**PLANNING COMMISSION MEETING
DECEMBER 01, 2021 AT 6:30 PM
505 EAST 2600 NORTH
NORTH OGDEN, UT 84414**

Staff Report to the North Ogden City Planning Commission

Application Request: Consideration and action regarding an administrative application, site plan approval of a building footprint expansion and parking lot expansion located at 2251 N. Washington Boulevard.

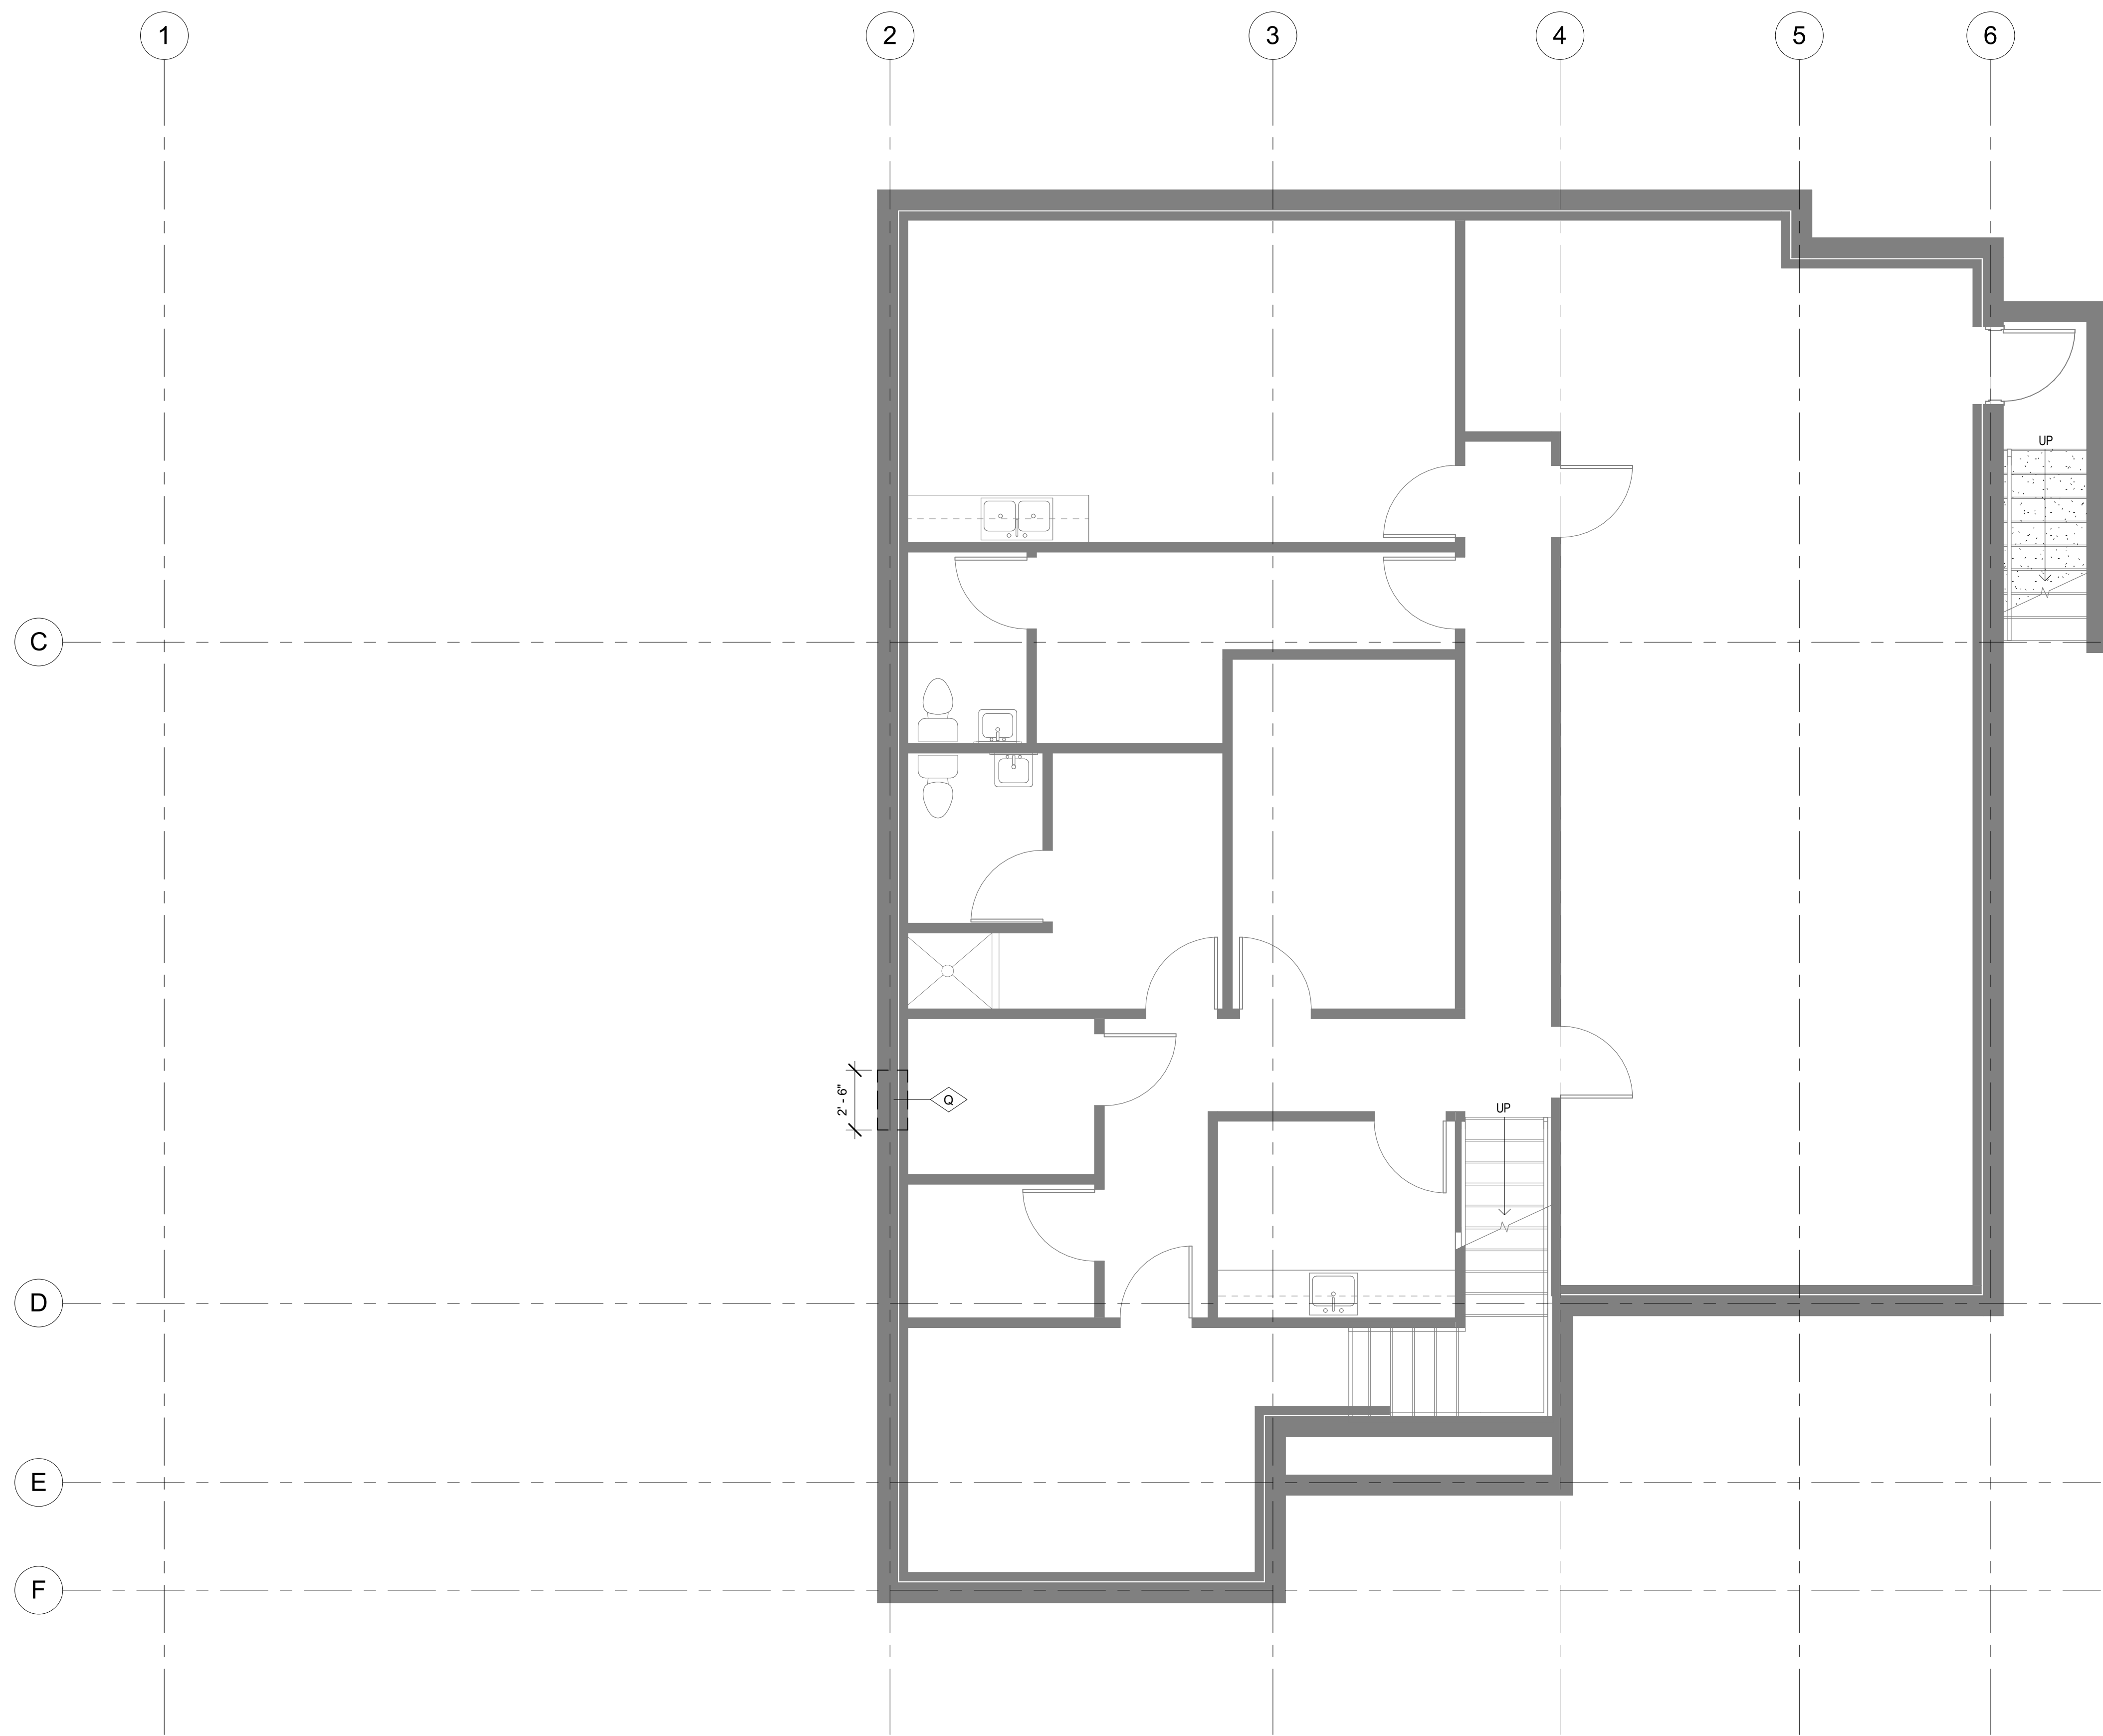
Staff Comment: The front setback is shown on the plan to meet the required 20' from the front sidewalk or property line. Further, the building plan is shown to meet the 10' required setback bordering a residential zone.

Staff Comment: The building architecture meets the requirements of the City Code. Pedestrian walkways have been provided from Washington Blvd. to the front entrance of the dental building as well as between the buildings adjacent to the parking lot expansion. Pedestrian walkways must be at least 5' in width. There is no dimension shown on the site plan.

Staff Comment: Landscaping on the site is largely mature trees, bushes, and turf grass. Most of the site will remain in its current state. The City Engineer's memo for the related Subdivision (SUB 2021-14), requires a grading plan for the parking lot expansion. Staff recommends that this be required to be submitted and administratively approved prior to building permit. There are three mature trees that will be removed. NOC 11-8D-4 (B) requires that mature trees removed be replaced at a 3:1 ratio. Staff

recommends that the Site Plan be updated to include nine additional 2" caliper trees around the site. This will replace the trees being removed, as well as meet the requirement of trees as they relate to parking areas.

Staff Comment: This section of the ordinance requires trees be planted in the ten foot setback area (See Exhibit B) at a ratio of at least 1 tree per 50 feet. There is currently a tree planted in the western portion of Parcel 2; this tree fulfills this standard.

Staff Comment: The parking area is only one drive aisle deep so there is no 'interior space' to landscape. The parking addition adds 14 spaces, but eliminates 8 spaces, for a net increase of 6 spaces. This increase does not require any additional parking lot landscaping.

Staff Comment: The building addition will be for the benefit of the dental office. The application includes a 1,244 square foot addition, which requires 5 parking spaces. The parking lot expansion includes a net increase of 6 additional spaces for the use of both the dental office and the existing office space to the north. Staff is of the opinion that the provided parking stalls are sufficient to meet the needs of the site, and that the parking requirements are met.

- Conditions specified in the Engineer's report, to include:
 - Low Impact Design for storm water impacts must be incorporated per Engineer's Memo
 - A Grading and Drainage Plan per the Engineer's Memo must be submitted and approved prior to issuing a building permit for the parking lot or building expansion.
- The Subdivision Application (SUB 2021-14) must be finalized and recorded prior to issuing a building permit for the parking lot or building expansion.
- The Planning Commission needs to determine whether the existing 6' fence accomplishes the goal of separation and buffering between commercial uses and residential.
- The pedestrian walkways shown on the plan, from Washington Blvd to the main entrance of the Dental Building, as well as connecting the two parking lots, must be 5' in width.

- The number, caliper, and height requirement for deciduous shade trees be met. This includes 9 total trees, of which 8 may be the required streetscape trees, planted in the park strip, spaced appropriately, as listed above.
- The sidewalk along Washington Blvd for the length of both Parcel 1 and Parcel 2 must be designed and installed at 10' total width and be planted with the approved small flowering tree species. This includes 4 trees between each of the existing streetlights for a total of 8 trees.
- Staff recommends these Site conditions be approved through administrative review of submitted documents prior to building permit.
